CHANGE ORDER
PROJECT: Big Creek Park Construction - Millington Levee

CHANGE ORDER NUMBER: 03
INITIATION DATE: 05/30/2023

COUNTY PROJECT NO: CA220686

Documentation of Costs for Change Order #3
 Big Creek - Phase 1D
 12/16/2022

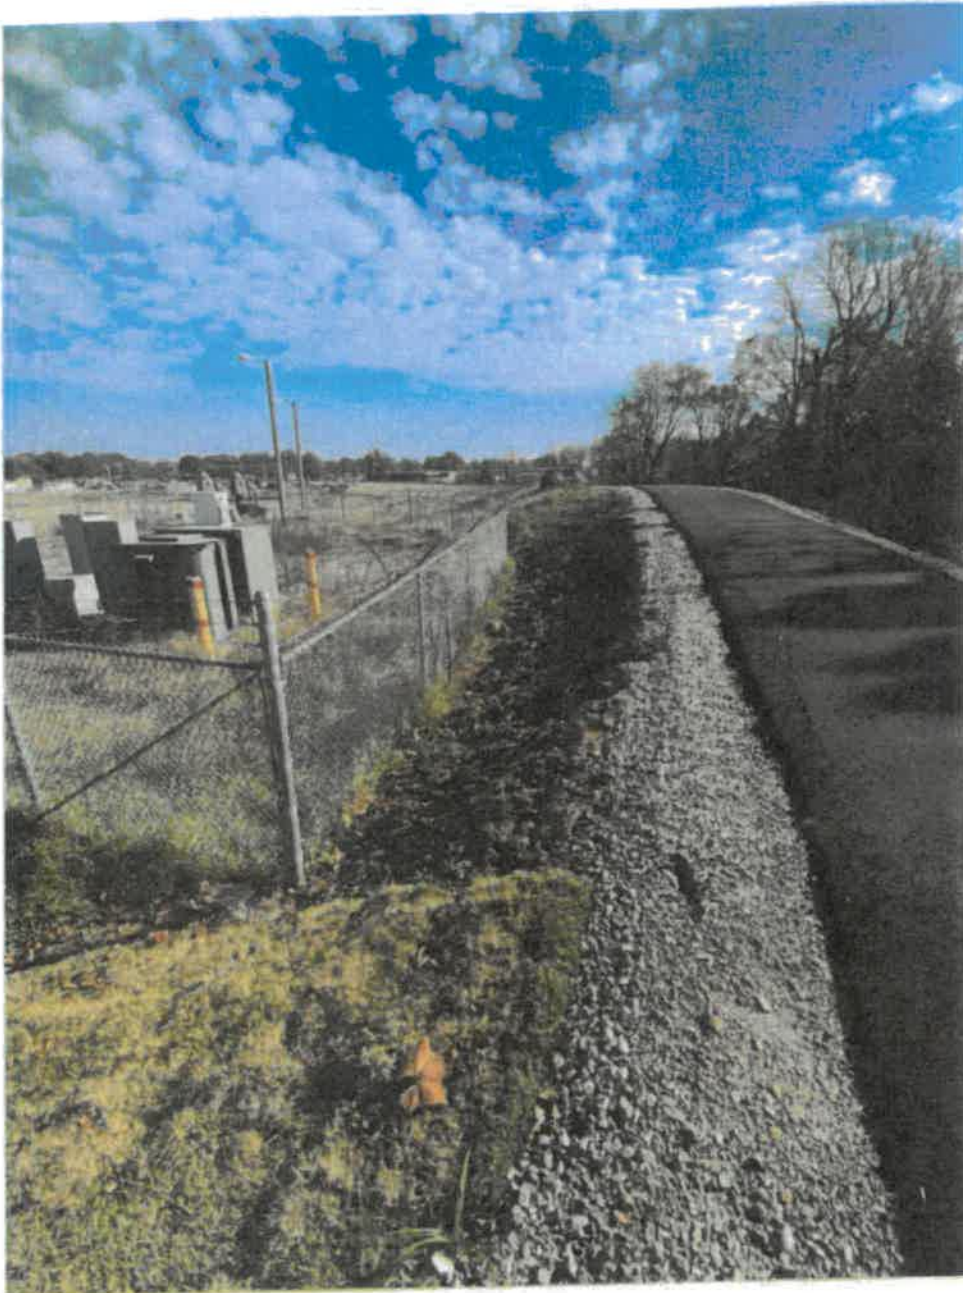
[This EMAIL was not sent from a Shelby County Government email address. Please use caution.]
The City of Millington requested that access be provided to their pump station from the levee. This access will be used during storm events when the basin is retaining water and access is required to the pumps. To accommodate this request sections of segmental wall are proposed to be removed to install an access ramp down to the pumpstation. The access road will require an additional 140 CY of material and approximately 22 tons of stone compared to the original design in this area. It is also estimated that 1198 square feet of wall will be removed from the project.

Since the embankment between the levee and the pump station security fence was placed at a slope steeper than 3:1, it is also recommended that an estimated 20 tons of Class A-1 riprap be placed to prevent erosion.

The additional fill in the City's detention basin for the access road amounts to less than 0.1 acre-feet of fill compared to the estimated 1,900 acre-feet of available storage at elevation 265.5 feet behind the levee. This minor reduction in available storage will not impact the water surface elevations behind the levee during a storm event.

These changes are captured in Addendum #2.
